<u>ENGINE - NO. 4 BEARING COMPARTMENT - PROVIDE A NEW NO. 4 BEARING PRESSURE TUBE ASSEMBLY - CATEGORY CODE 6 - MOD.ENG-72-0115</u>

SERVICE BULLETIN

V2500-ENG-72-0115

Location of the No.4 Bearing Pressure Tube Assembly Fig.1

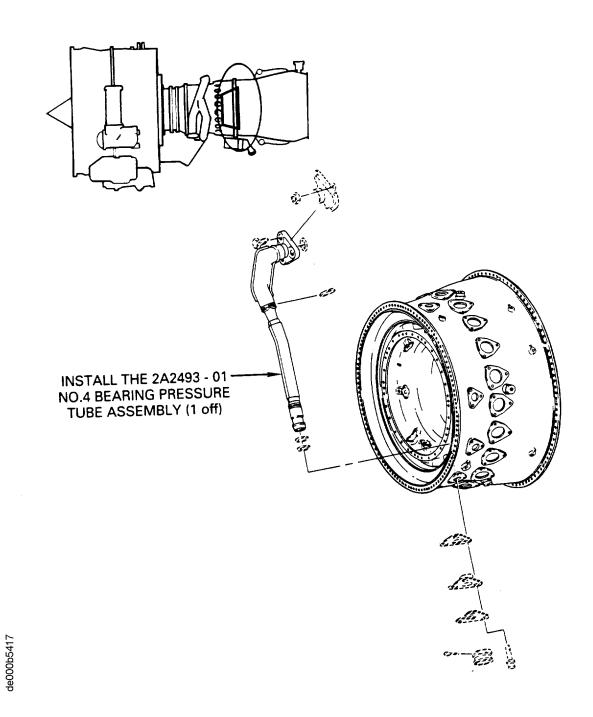
Internal oil coking has been found near the holes in the No. 4 Bearing Pressure Tube Heat Shield.

Borescope inspection of the No. 4 Bearing Oil Tube Assemblies on two test engines showed internal oil coking. It was found that the coking was caused by the two gaps, formed by the two cut-outs which are at each corner of the two Oil Tube Heat Shield Halves.

(1) A new No. 4 Bearing Pressure Tube Assembly with new heat shields that do not have the gaps at each end of the heat shield halves.

- A. Rework Instructions
 - (1) There are no rework instructions necessary to accomplish this Service Bulletin.
- B. Assembly Instructions
 - (1) Install the 2A2493-01 No.4 Bearing Pressure Tube Assembly (1 off). Use the approved procedure in Reference (1), Chapter/Section 72-42-10, Assembly.
- C. Recording Instructions
 - (1) A record of accomplishment is necessary.
